Public Market - Parcel B FDP

Appeal response

April 25, 2019

Applicant Presentation

Parcel B – PDP vs. FDP Consistency

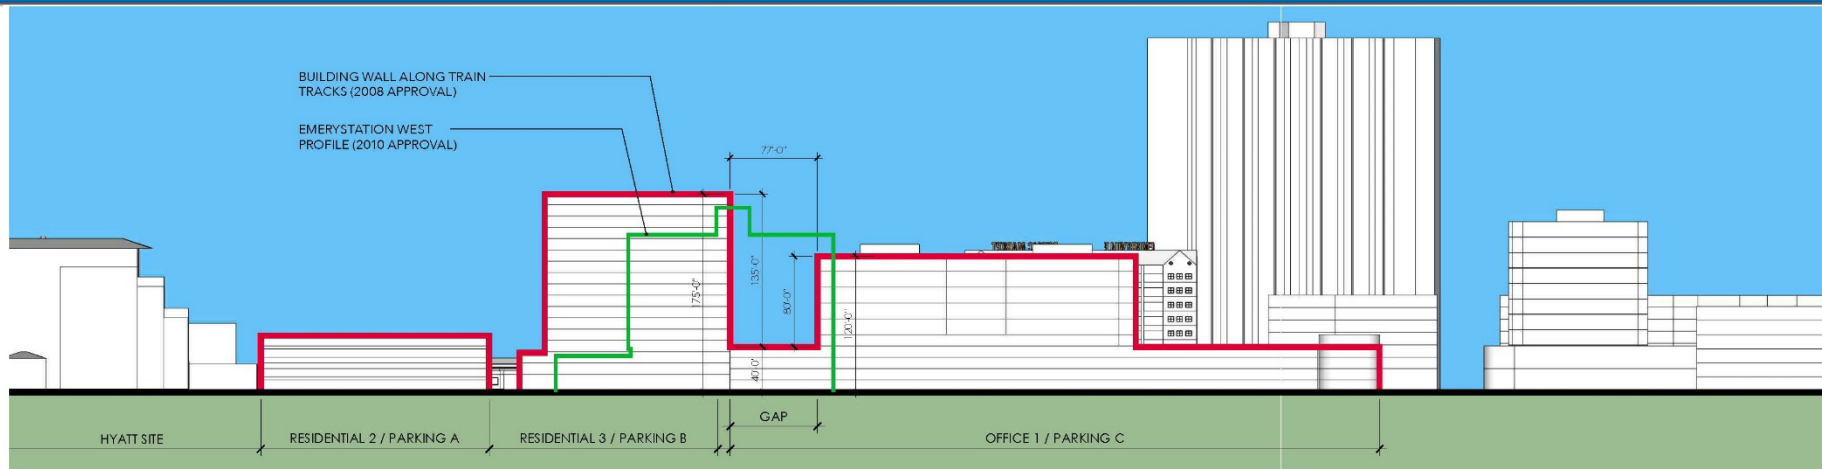
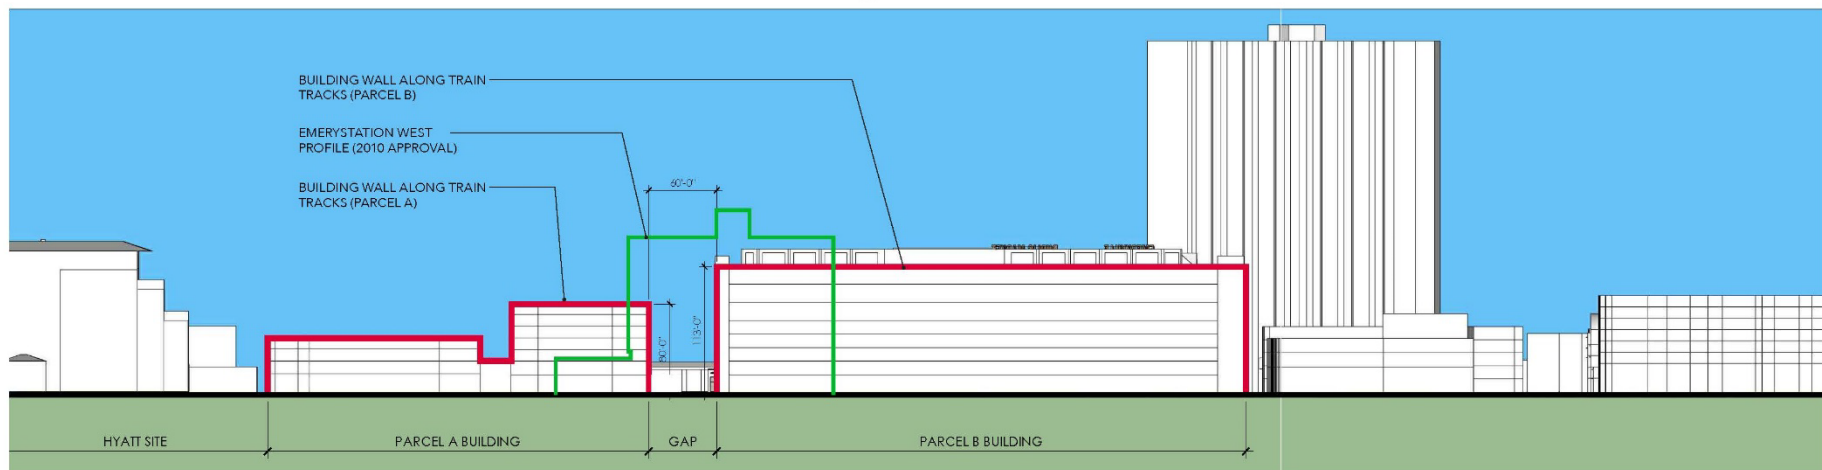
Comment 1 – Project design does not conform with PDP's design requirements

- » The East wall design has been carefully designed. The East and West facades of the building are similar in their size, proportion, quality of windows, wall systems, expressed frame system, articulation of roofscape elements, open parking level design and expression, and articulation in the massing.

| | WALL AREA ALONG TRAIN TRACK FRONTAGE | Δ |
| Figure 1. PDP | 85,021 SF | - |
| Figure 2. FDP | 72,768 SF | 15% LESS |
